# 今日唐人街 *Chinatown Today*

## **Letter of Opposition Towards 105 Keefer**

## Appendix: Criteria and Application to 105 Keefer

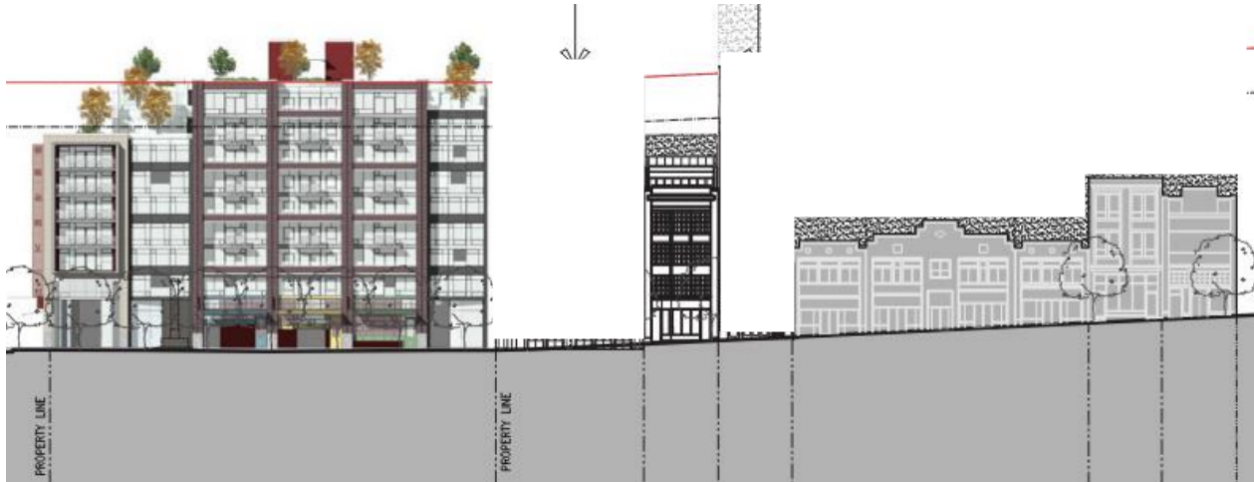
Uniform rooflines without setbacks facing the Keefer Street (top) and Columbia Street (bottom).<sup>44</sup> The scale of this development, at 9 storeys, across a large, consolidated lot with relatively uniform roof lines, is specifically discouraged by the Design Guidelines.<sup>45</sup> Further, Beedie’s design does not appear to conform with the setback requirements above 21.3 m or the rear setback requirements for residential upper floors.<sup>46</sup> The massing of the development fails to embody the prominent saw-tooth profile identified as important by the Design Guidelines.<sup>47</sup> Further, the building does not respond to the context of the block (as demonstrated by the impacts to the Chinatown Memorial Square, Chinatown Memorial Monument, and Dr. Sun Yat-Sen Park), lacks a distinctive “saw-tooth” profile, and the uniformity of the facades facing the Keefer and Columbia Streets fails to maintain the “fine grain

streetwall pattern” characteristic of Chinatown.<sup>48</sup> The overall massing and building height push the limits of the zoning; 105 Keefer is dramatically taller than nearby buildings, such as the Goldstone building, the Chinese Canadian Military Museum, and the buildings of the Dr. Sun Yat-Sen Park & Classical Chinese Garden.<sup>49</sup>
